BAR Meeting
January 19, 2011

ISSUE: Permit to Demolish/Encapsulate & Certificate of Appropriateness
(Alterations and Enclosure of an Existing Open Porch)

LOCATION: 325 South Lee Street

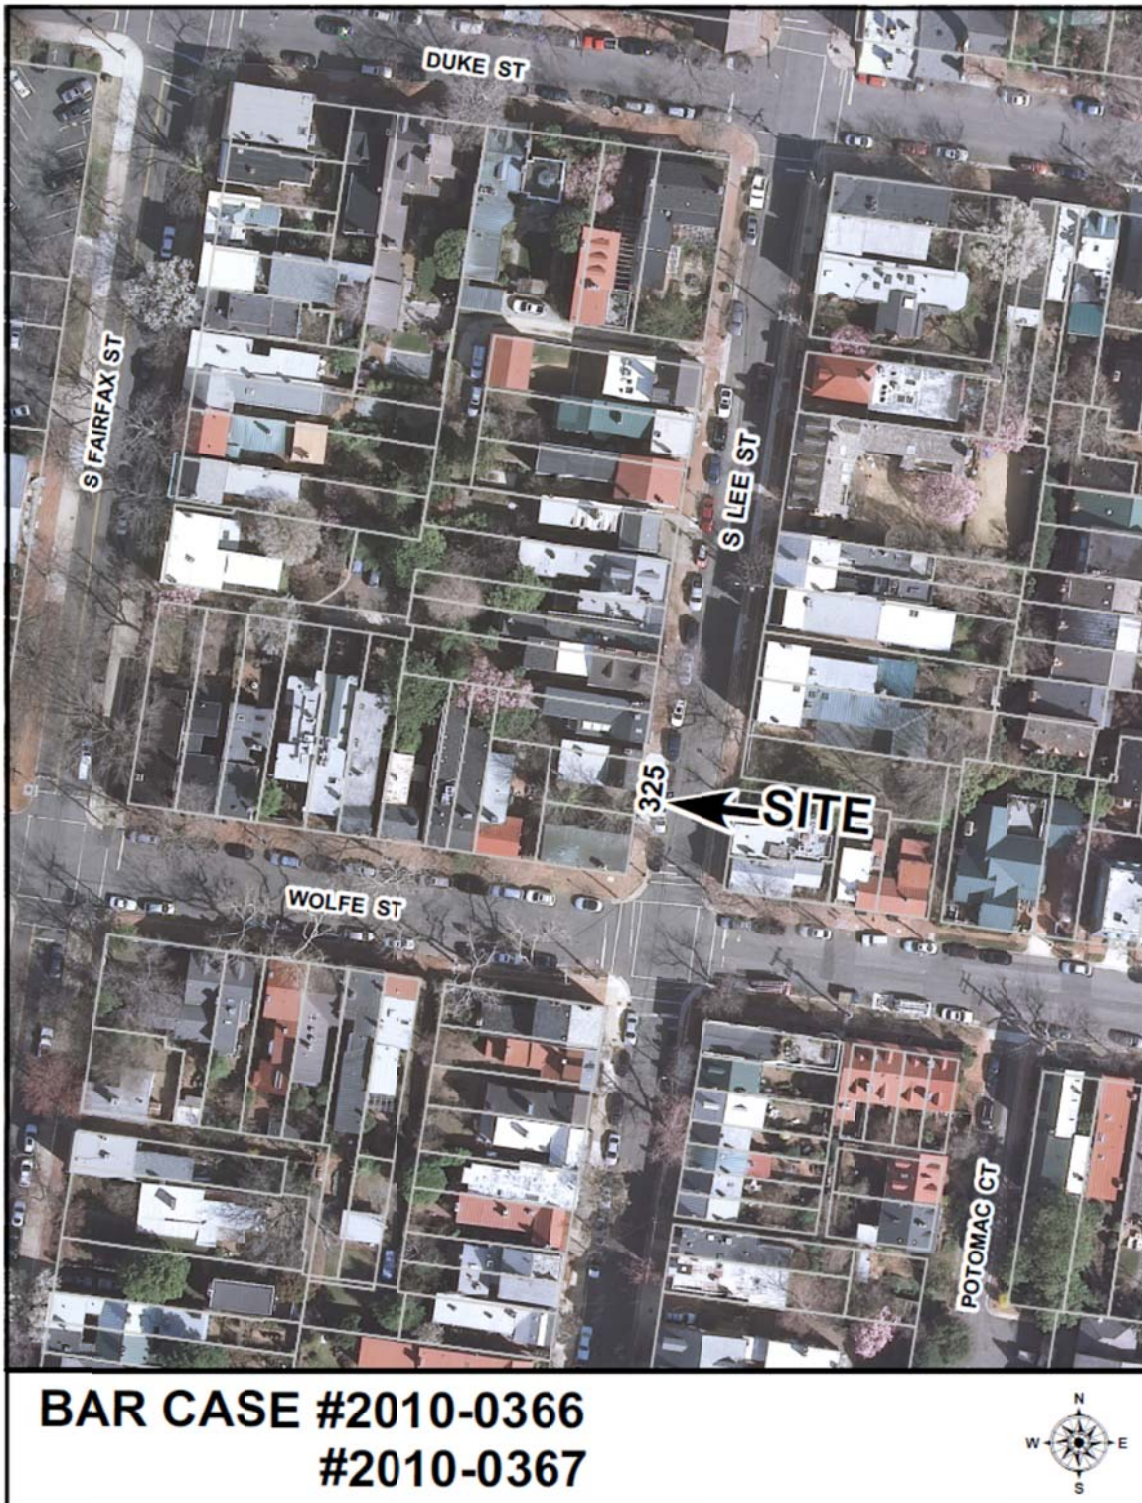
Chairman Hulfish stated that he did not like the batten design. He preferred that the porch remain open or have temporary glass panels mounted at the back of the posts. He had no problem with a lowered floor but did not want this to read as a glass wall.

Mr. Carlin said that open porches are artifacts of the past and that they are not used the same way today. He does not like the batten scheme and suggests storm sashes on the south side with ventilation openings on the west side.

Mr. von Senden did not care for the batten solution.

Mr. Fitzgerald preferred removable panels with the glass set behind the column.

Mr. Neale did not like the battens and preferred that glass be set behind the balusters. He moved to defer for restudy.

Figure 6: Proposed Elevations

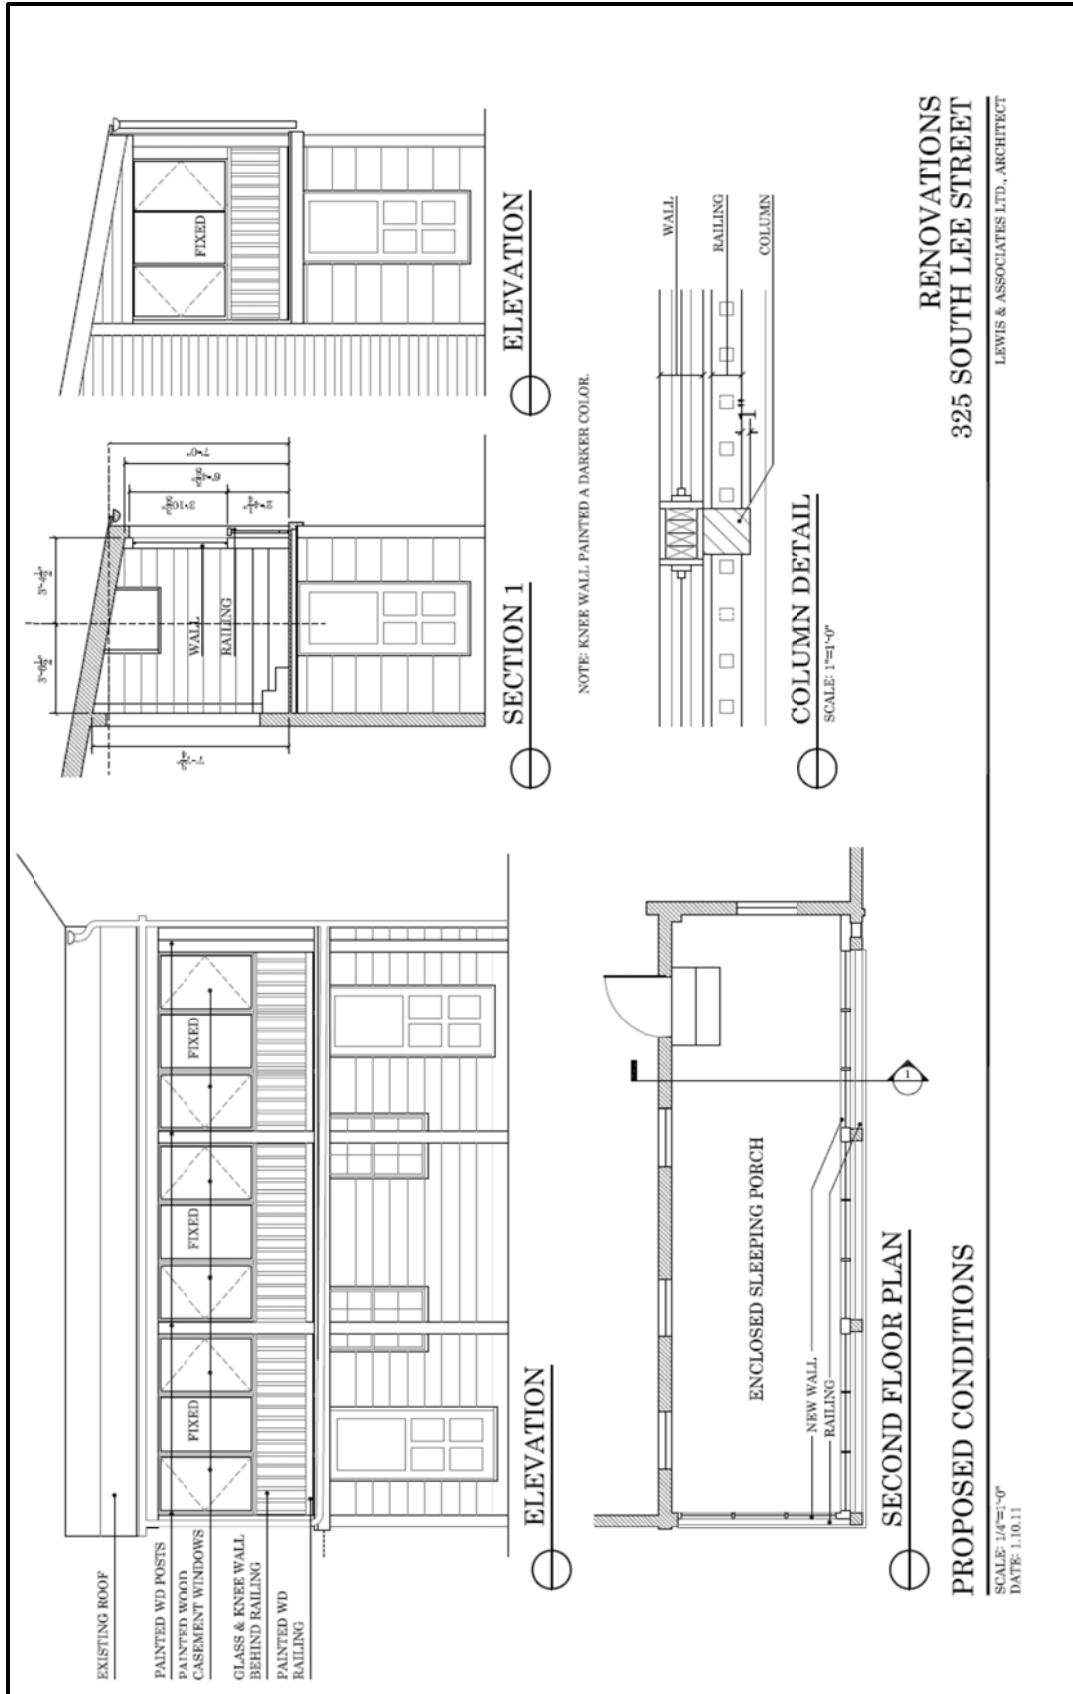
1. Reconstructing the porch columns and balustrade. (The columns and railings will be painted to match the house trim.)
2. Constructing a new 2'4-1/4" high knee wall capped with fixed sash and casement windows behind the new porch columns and balustrade. (The knee wall and the window trim will be painted a dark color.)

- **Enclosure of the second story of the existing, two-story shed roof open porch along the north elevation of the ell. The 6 x 6 porch columns will be replaced in-kind and a 2' 4-1/4" high, square picket balustrade will be installed. The new enclosure will be assembled behind the reconstructed columns and new balustrade. It will be constructed with a 2'4-1/4" high knee wall capped with fixed sash and casement windows. The knee wall and the window trim will be painted a dark color.**
